PORTER-CABLE

BELT SANDER

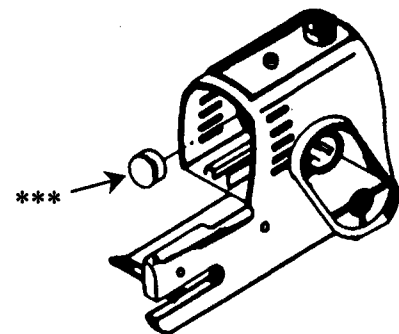
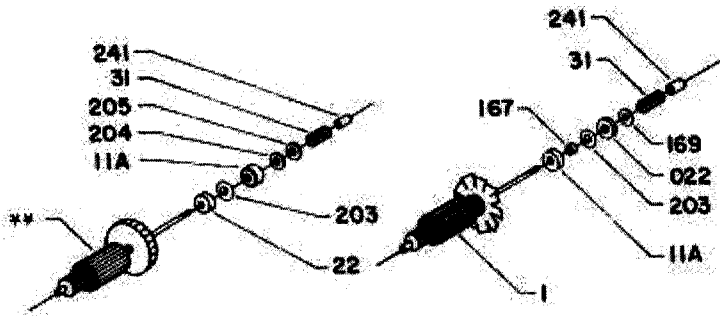
MOVE FROM EARLY MODEL

ADD TO CURRENT MODEL

*** #863624 Sleeve reduces seal bore in frame #841033 to accept new seal. Press sleeve to stop in bearing bore of frame.
